DOE/EIS-0089

# **ADDENDUM TO ENVIRONMENTAL IMPACT STATEMENT**

## **Operation of PUREX and Uranium Oxide Plant Facilities**

**Hanford Site  
Richland, Washington**

FIGURE 3.1. PUREX/UO<sub>3</sub> Facilities and Other Hanford Facilities

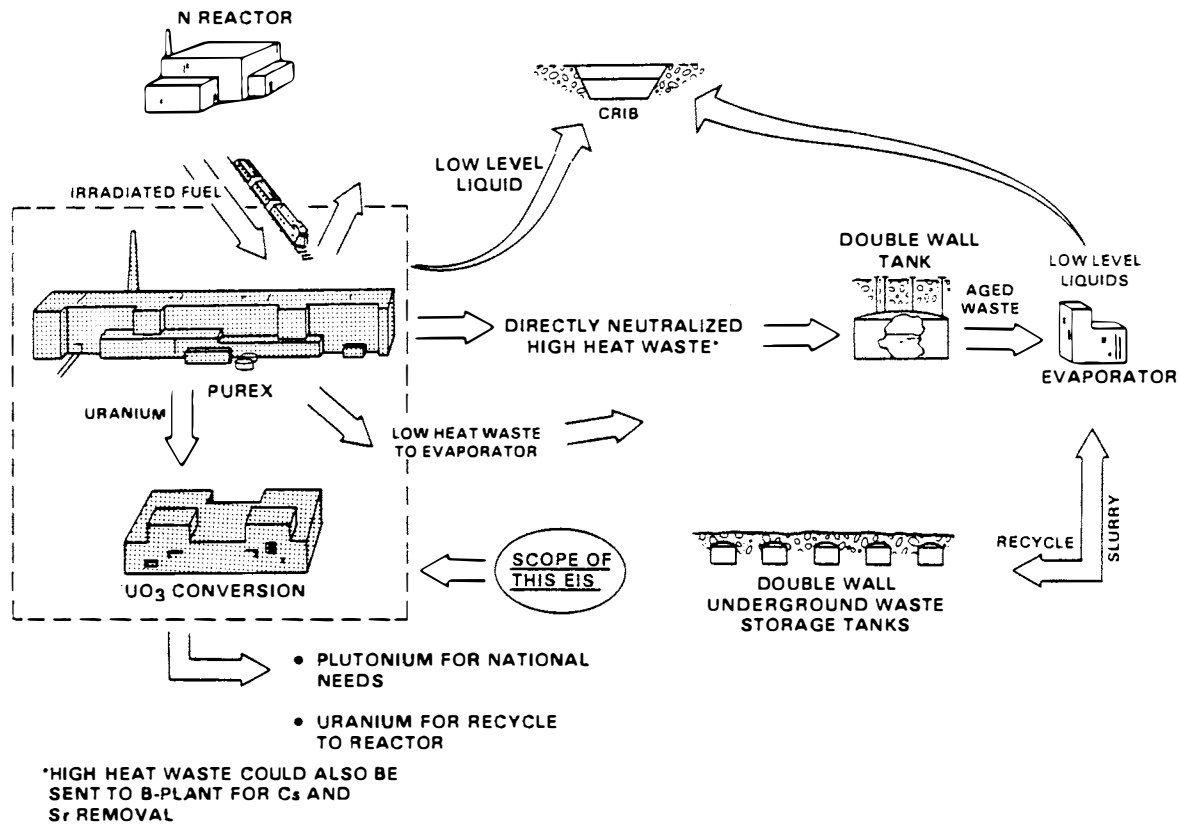
Replace Figure 3.1 with the Figure shown below.

Reason: Factual correction.

FIGURE A.3. Uranium Final Cycle Process Flow Diagram

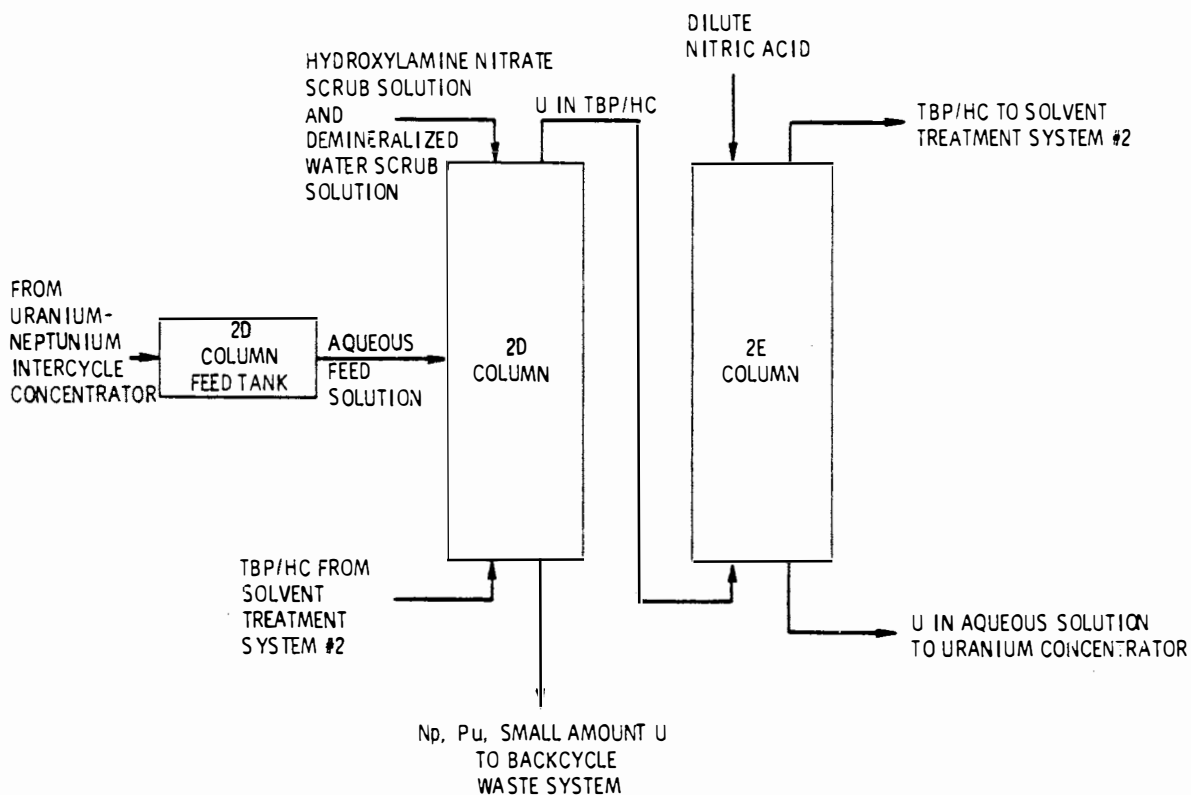
Replace Figure A.3 with the figure shown below.

Reason: Factual correction.
